REQUEST FOR A WAIVER FROM THE AMERICAN IRON AND STEEL REQUIREMENT

PENNVEST Funding Recipient	<u>Independence-Cross Creek Joint Sewer Authority</u>
PENNVEST Project:	<u>Independence Village and Cross Creek Village Sanitary Sewer System</u>
ME Number:	<u>75308</u>
Recipient/Engineer Contact Name:	<u>Kevin L. Szakelyhidi, PE</u>
Telephone:	<u>(412) 767-5100</u>
Email:	<u>kevins@banksonengineers.com</u>

Submittal Cover Sheet

Project Independence Village And Cross Creek Village Sanitary Sewers Contract 16-1

MODEL 3700V

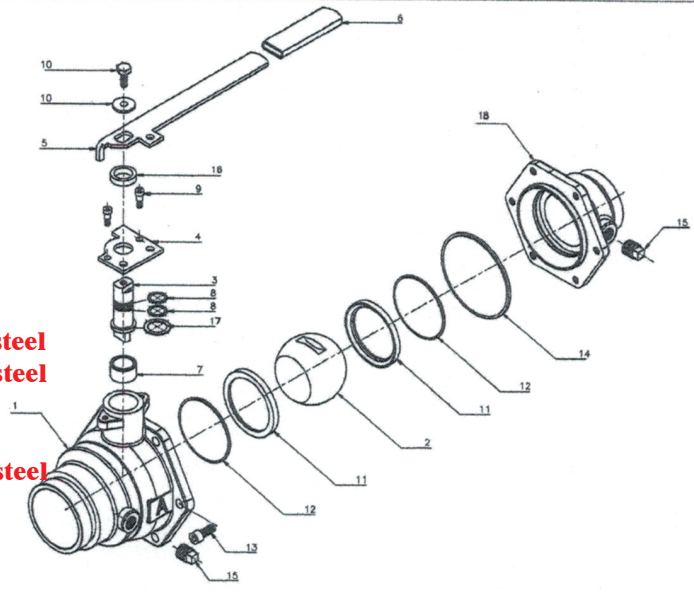
This furnish as corrected approval is conditioned upon the receipt of a waiver regarding AIS compliance.

Part	Material
1 Body	Cast Iron/A48 Class 30
2 Ball	Cast Iron/PFA* Fused
3 Stem	Stainless Steel
4 Stop Plate	Steel- May be steel
5 Handle	Steel- May be steel
6 Handle Grip	Vinyl Dipped Plastisol
7 Sleeve	Stainless Steel
8 Stem O-Ring	Nitrile Rubber (Buna-N)
9 Shoulder Screw	Steel- Must be stainless steel
10 Stem Bolt/Washer	Steel- Must be stainless steel
11 Seat	Virgin PTFE
12 Back Seat O-Ring	Nitrile Rubber (Buna-N)
13 Socket Head Screw	Steel- Must be stainless steel
14 Body Gasket	Nitrile Rubber (Buna-N)
15 Body Plug	*
16 Collar	Steel- May be steel
17 Thrust Washer	PTFE
18 Body Cap	Cast Iron/A48 Class 30

The valve trim is to be stainless steel except that the (#4)stop plate, handle (#5) and collar (#16) may be carbon steel. To the extent that items are needed when the valve is equipped with a 2" square operating nut, the screws and other attachments are to be of stainless steel and not carbon steel. The 2" square operation nut, however, my be of steel.

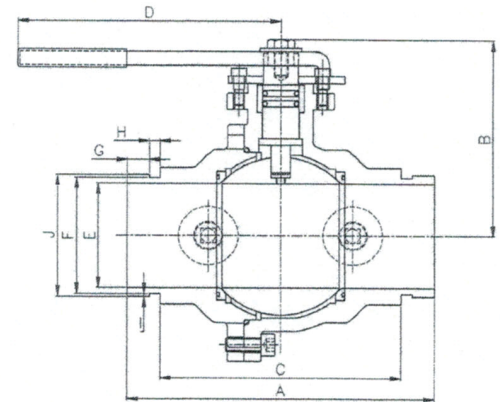
Valves will be supplied with 2" operating nut

The 2" valves which are to be installed vertically below the air valves (currently a total of 18 two-inch valves) are to have lever operators. All other valves are to have 2" square operating nuts.
